SUBJECT: REPLY TO A NOTICE OF NONCONFORMANCE - 99901350/2003-201

REPLY TO A NOTICE OF NONCONFORMANCE

99901350/2003-201

1- 600V, 3/C, 500MCM, Copper, Non-magnetic installation

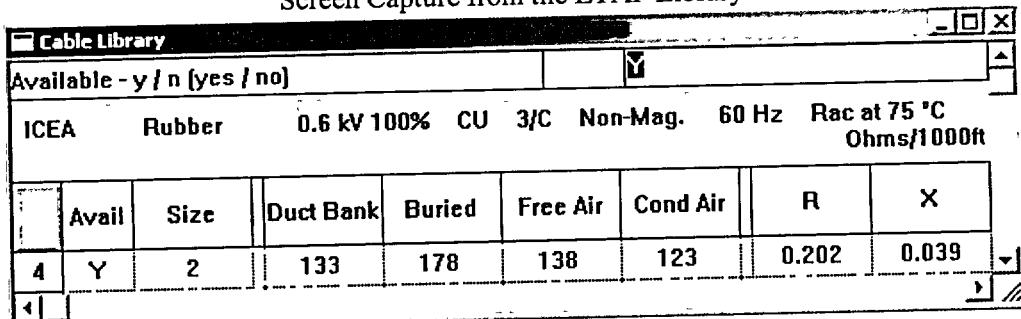
B-2. NRC – “OTI failed to ensure that ETAP-PS library ampacity derating design data for “free air” licensee applications was the same as that specified in Insulated Cable Engineers Association (ICEA) Standard P-46-426 for free air values.”

OTI: Contrary to the above statement, cable ampacities for ETAP ICEA cable libraries are in fact correct and are based on ICEA Standard P-46-426. This item was not discussed as an issue in the NRC inspection or during the exit meeting; therefore, OTI did not have an opportunity to provide clarification. To OTI’s surprise, this inquiry is documented as a non-conformance in the NRC report.

The inspector did not compare the correct ETAP cable library data with the data selected from the ICEA-P-46-426 Standard. The inspector must select non-magnetic installed cables for comparison of the free air ampacities.

The comparison tables below show that the ETAP library data match the ICEA values. Screen captures of the ETAP library data are also provided for verification.

Base Ampacity for 3/C 500 MCM Copper, 600V				
	Duct Bank	Buried	Free Air	Conduit in Free Air
ETAP	429	531	487	425
ICEA-P-46-426	429	531	487	425
